REFERENCE
LHC-TC-EC-0013

Date: 2017-04-18

ENGINEERING CHANGE REQUEST

Installation in IR7 of Dispersion Suppressor Collimators (TCLD)

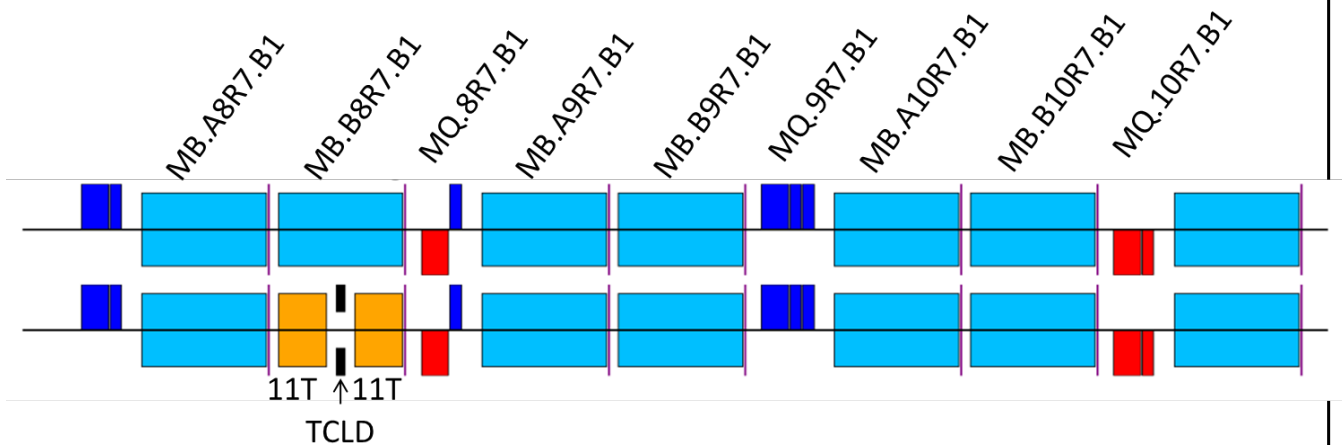
Simulations and present knowledge of the quench limits of the standard dipoles as well as the 11 T magnets have shown that the preferred placement of the TCLD is in cell 8 (on the right side of IR7 for B1 and left side for B2) [7]. The standard dipoles to be replaced by the assembly of two 11T magnets are MB.B8R7 and MB.B8L7. The schematic layouts of the present and post-LS2 IR7 dispersion suppressor on the left side of IR7 are shown in Figure 1.

Figure 2 - Positions of new TCLD collimators in IR7. Figure taken from Ref. [12].

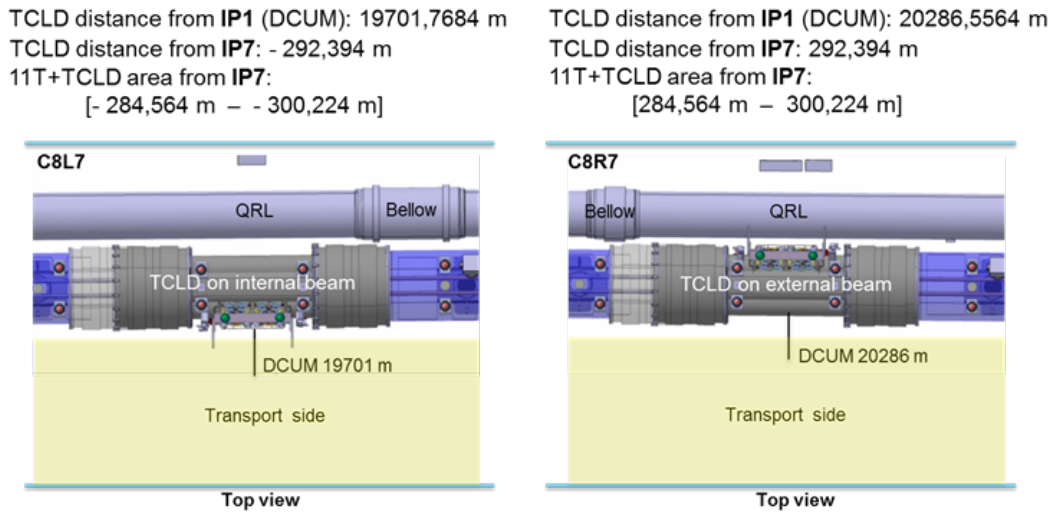
The integration and positions of the two TCLDs are shown in the drawings in Figure 2. More details on the integration are presented in [12].

Figure 3 – Drawing of one of the TCLD jaws (top), including RF fingers, cooling pipes and BPMs, and the two jaws installed on the table (bottom). Courtesy of L. Gentini.

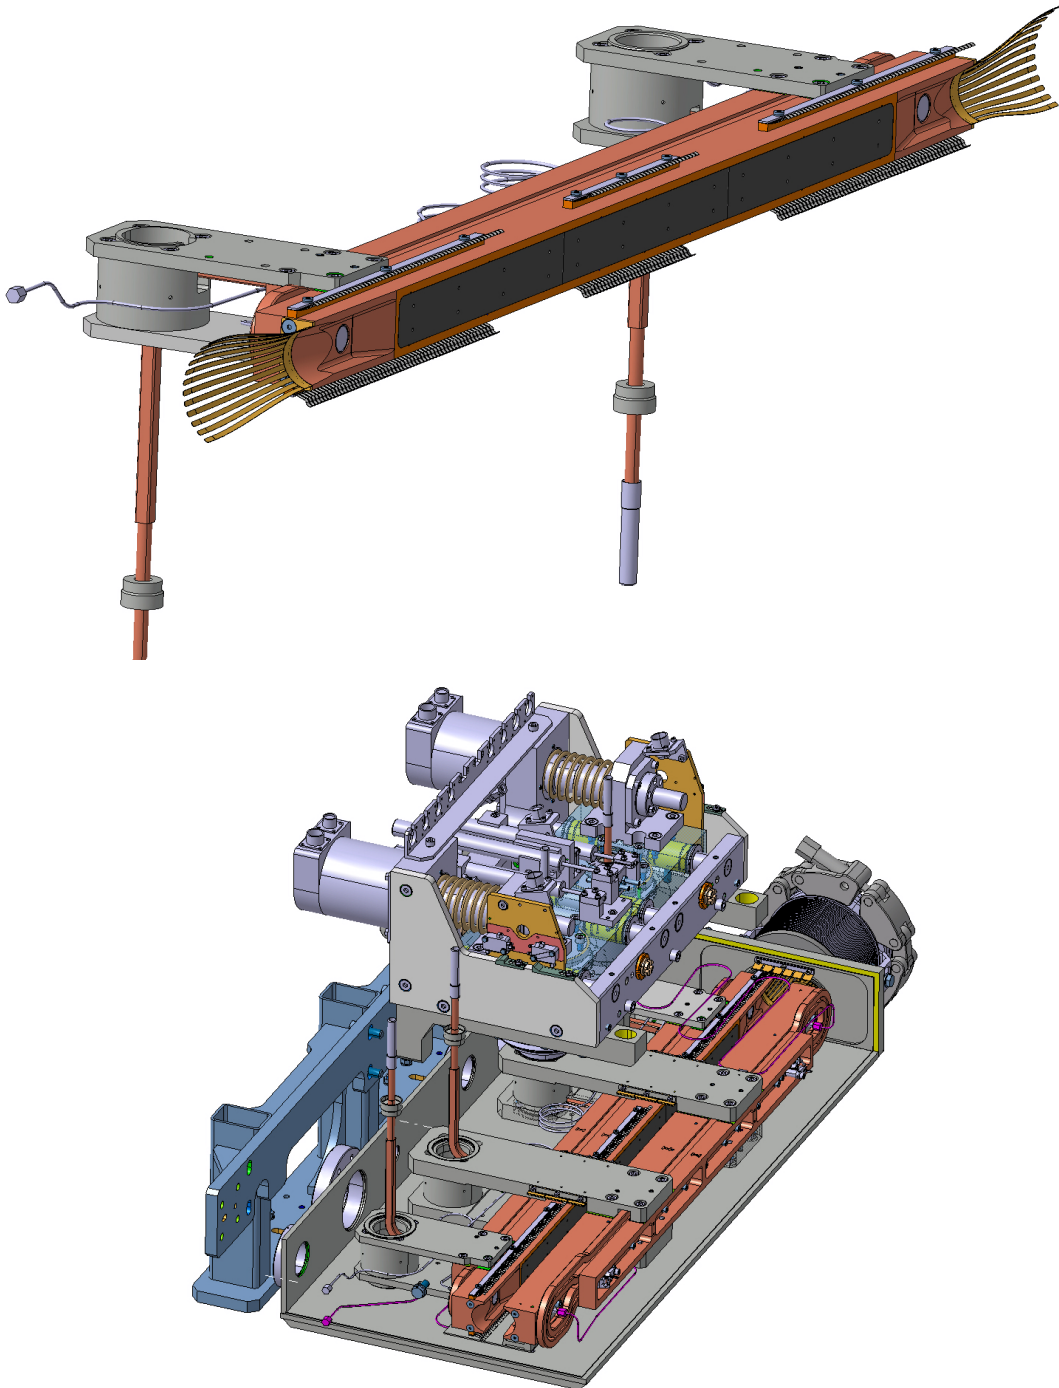
The TCLD consists, as most other LHC collimators, of two parallel jaws collimating the beam in the horizontal plane, with the beam passing in between them. The active material of the jaws is the tungsten alloy Inermet 180. The design of the TCLD collimator, shown in more detail in Figure 3 and Figure 4, is derived from the design of the present LHC collimators, but with some differences. Because of the very tight space requirements, the design is challenging and the active length of the material had to be reduced to only 60 cm, in order to make it fit. This means that also a non-standard support design is used. The shorter length has only a minor adverse effect on the downstream energy deposition [10,11]. Furthermore, the bellows at the two longitudinal extremities are integrated in the tank transitions in order to gain longitudinal space. A 3D drawing of the tank and support is shown in Figure 5.

The actuation system does not include any movement in the vertical plane, which allowed to reduce the jaw height. Otherwise, each jaw can be independently moved by two stepping motors per jaw, which maintains the possibility to tilt the jaws in the horizontal plane. The maximum opening of each jaw is 25 mm from the centre, 5 mm less than for standard collimators, and the stroke across the centre is 5 mm.

As all recent collimators, the design includes two BPM buttons per jaw, integrated at the extremities outside of the tapering. The jaws feature water cooling, using squared 9 mm pipes. Each jaw contains also 3 LVDT position sensors and 2 TP100 temperature sensors.

Figure 6 – The assembly to be installed between the two 11T dipoles, consisting of TCLD collimator, support, beam pipe for the other beam, and cryo-bypass. Courtesy of L. Gentini.

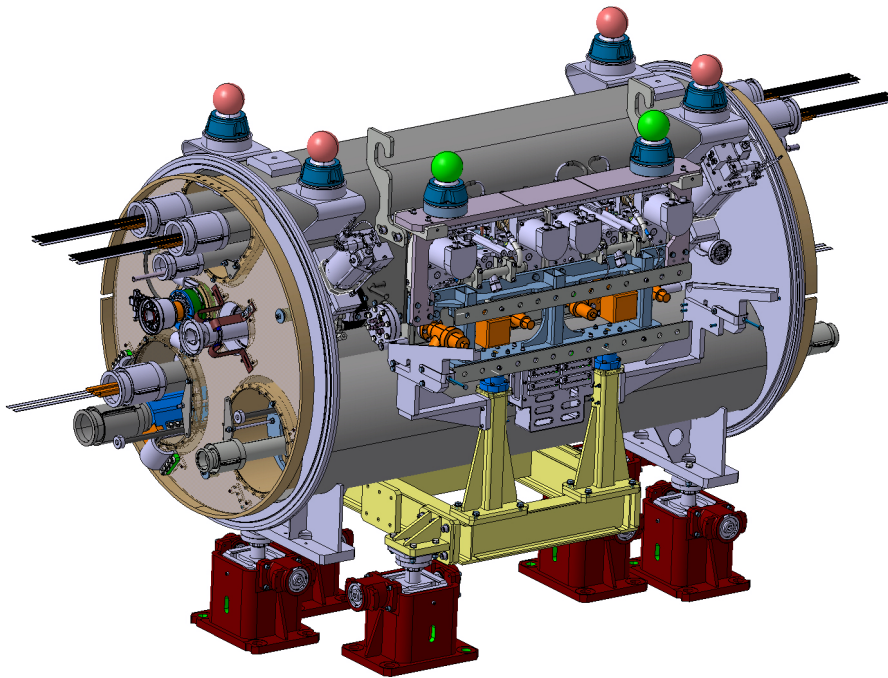
The TCLD will be integrated in a specially designed assembly, containing a beam pipe for the other beam, as well as a cryo-bypass, which is needed since the TCLD is a warm element placed between two cold ones. This assembly is shown in Figure 6 and the full installation including the two 11T dipoles is shown in Figure 7.
